CHANGES TO THE SPECIFICATIONS

CHANGES TO THE PLANS

REVISIONS
STEVEN M. CLOUSE WRC
PRIMARY CLARIFIER
REHABILITATION
PRIMARY CLARIFIER
PLAN AND SECTION

MAP NO.
 SECT. NO.
 DR. EG CK. JG JOB NO. 21-0111 SHEET M-08 230F28

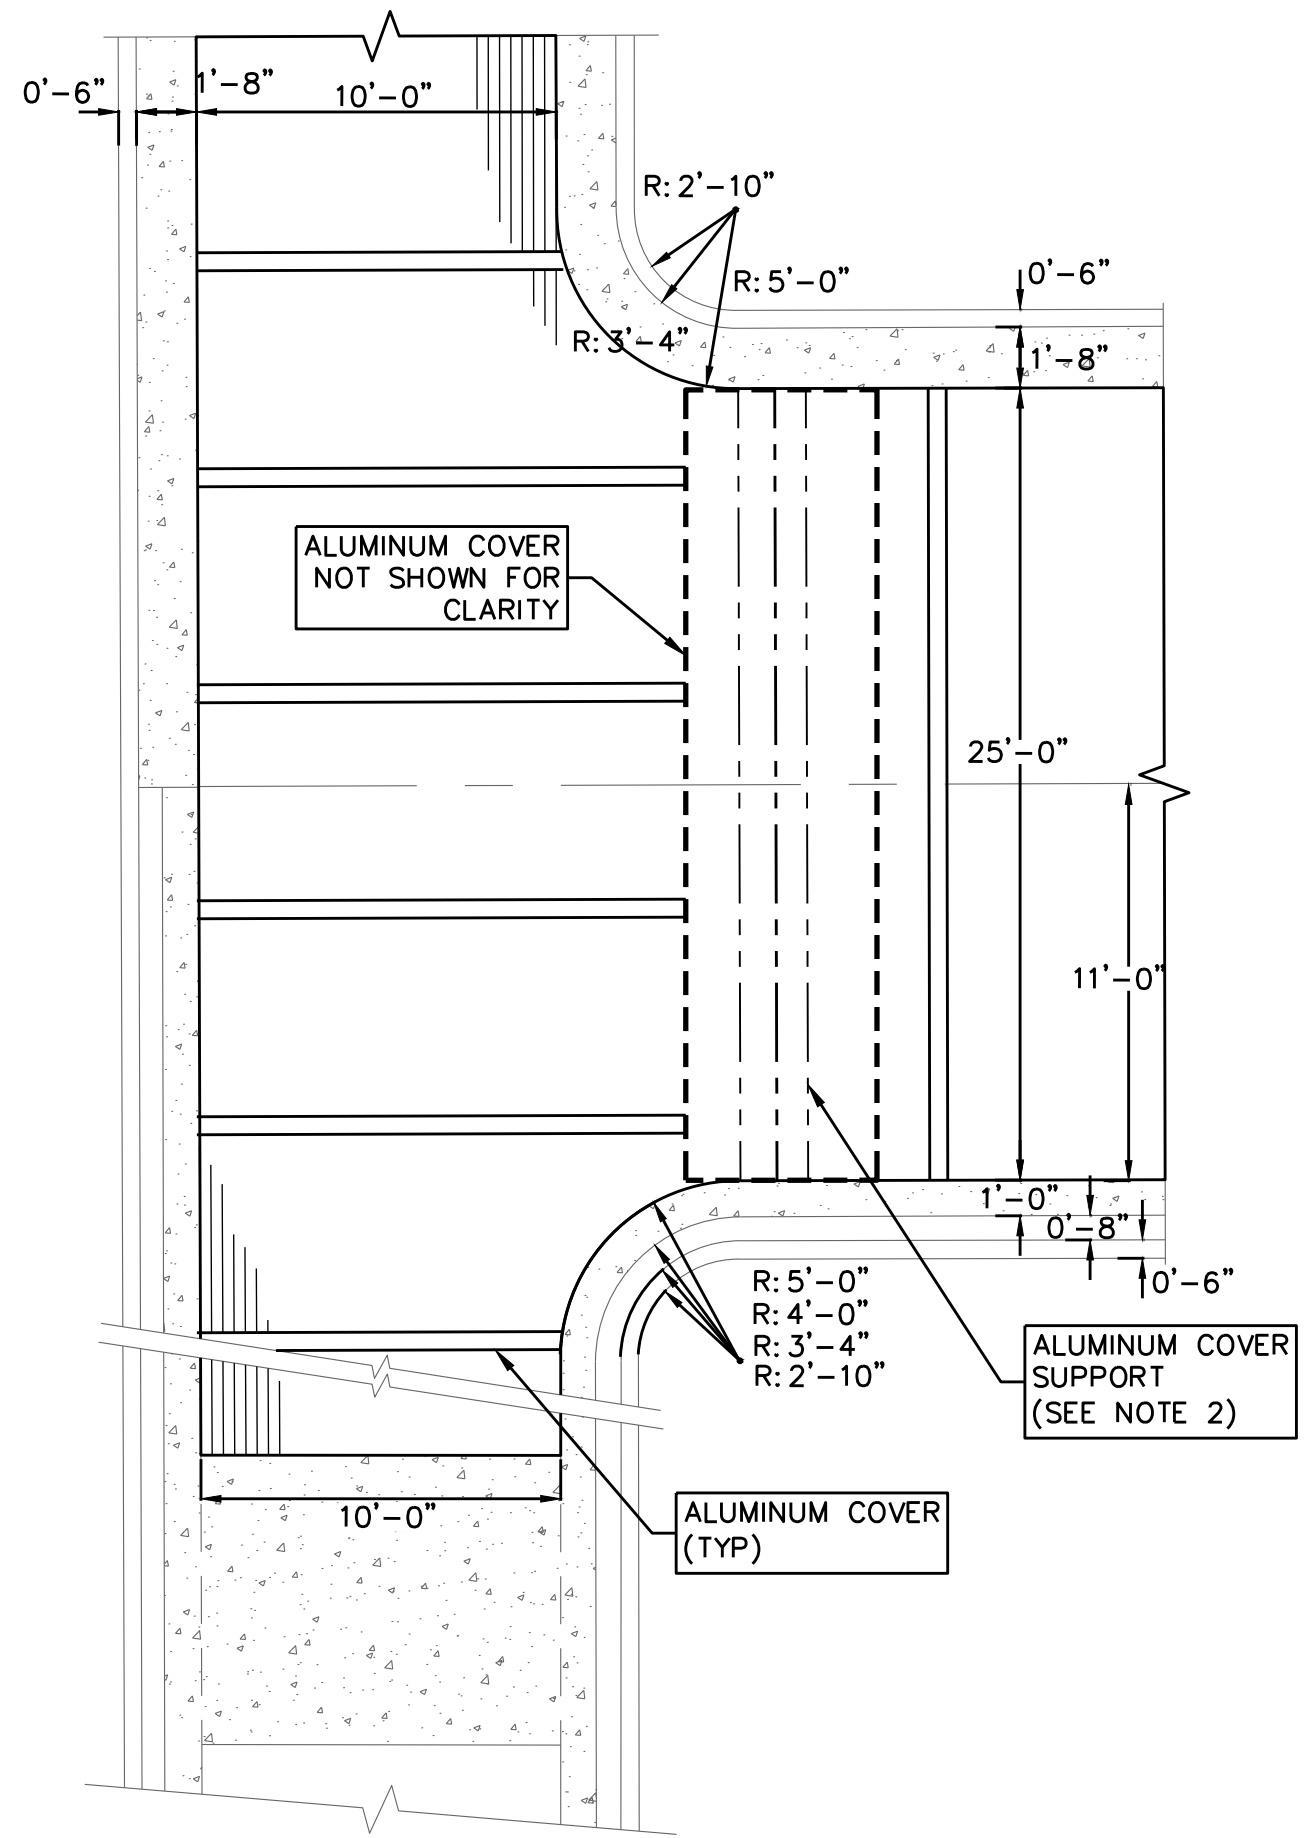
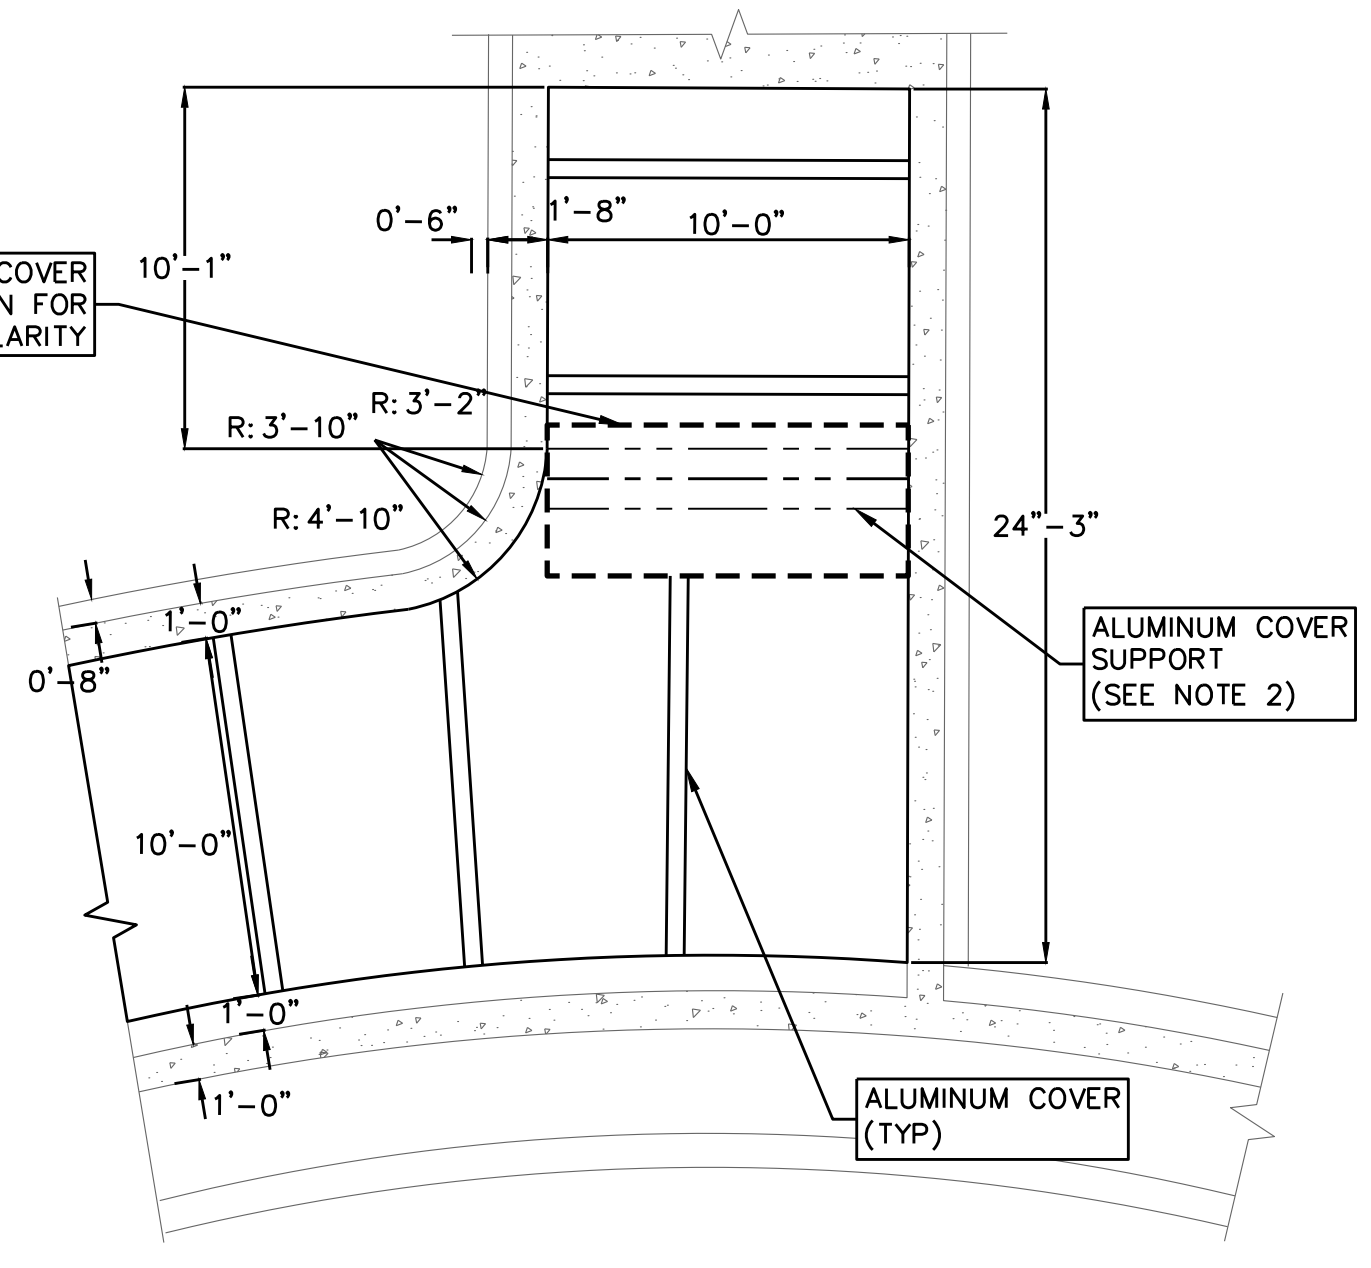
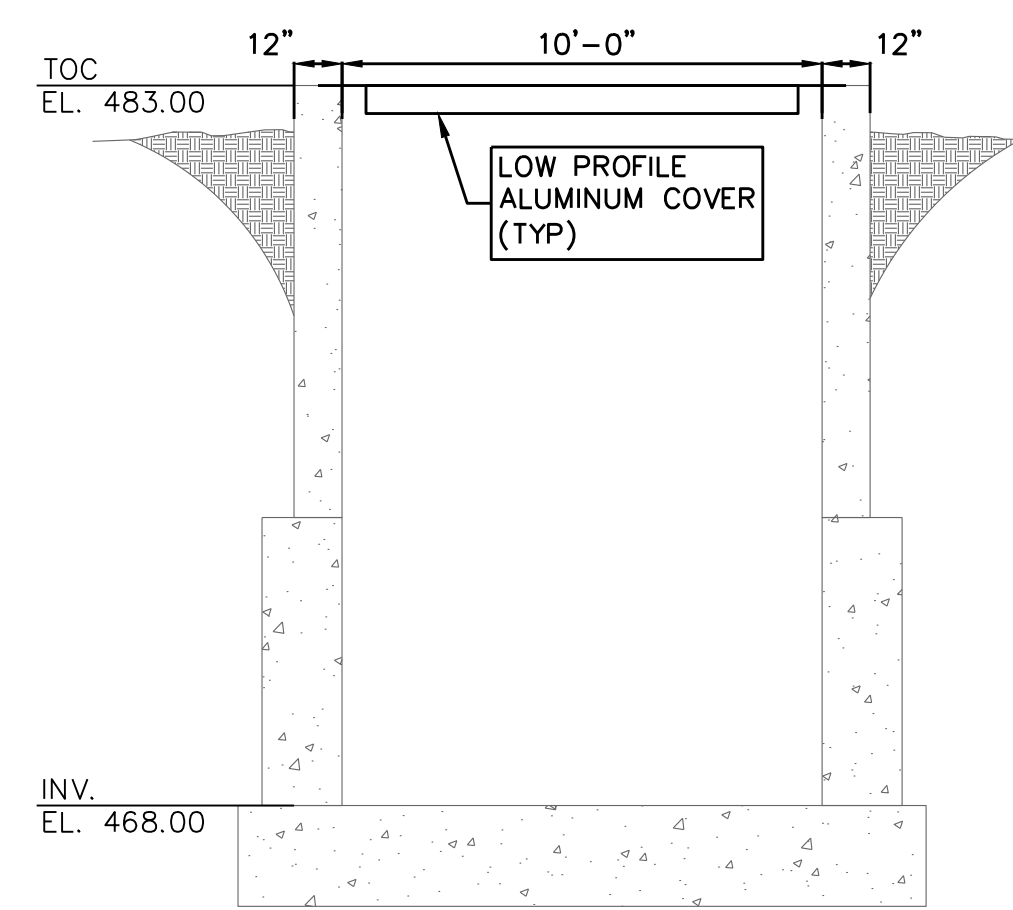
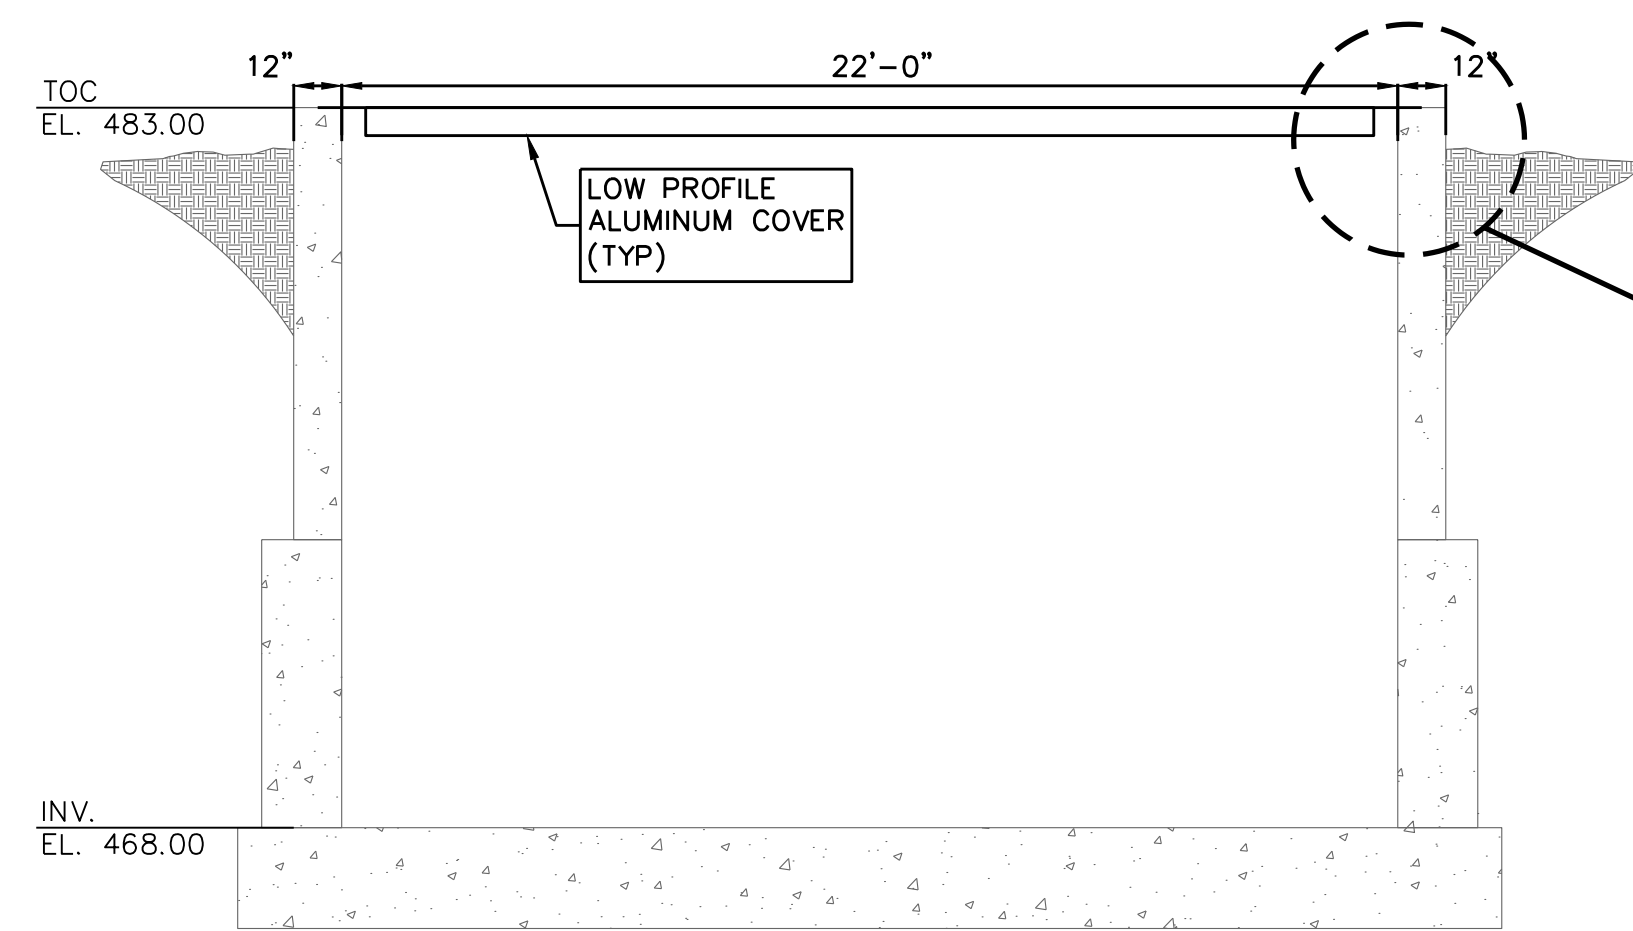
- We had a question regarding the Aluminum Covers specified for the Steven M Couse WRC job bidding next week. Can you please provide clarifications for the dimensions in the below drawing in order to quote the aluminum cover?

Response: Sheet M-08 was revised to clarify which areas will require aluminum covers.

Response: Additional dimensions were added to Sheet M-08. The proposed cover area is approximately 12,050-sf. The area calculation is provided for information purposes only. Contractor is required to confirm cover area from the plans.

D
DETAIL
SCALE: NTS

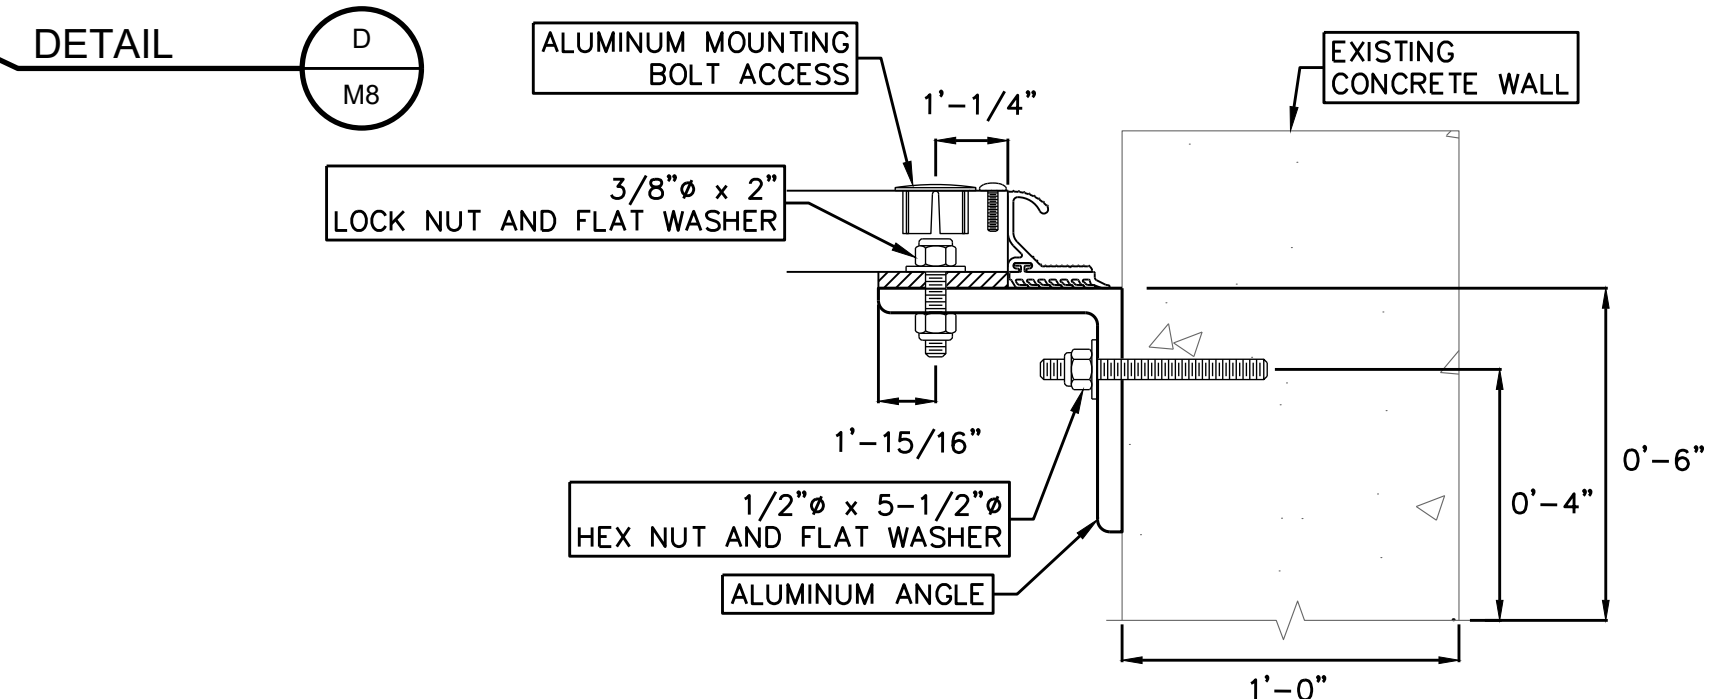
- Is the ledger angle mounted cover detail highlighted on section D/M8 the type and profile of covers wanted for this project? This detail contradicts Part 2.3 A. 4. of specification section 13 34 23 that reads, "Installed cover system walking surface elevation to be a stepped vertical increase to a maximum of 3/4 inch above tank wall." Either design can be provided. Please advise which type of cover is desired.

Response: The cover shall be set flush with the top of the concrete wall.
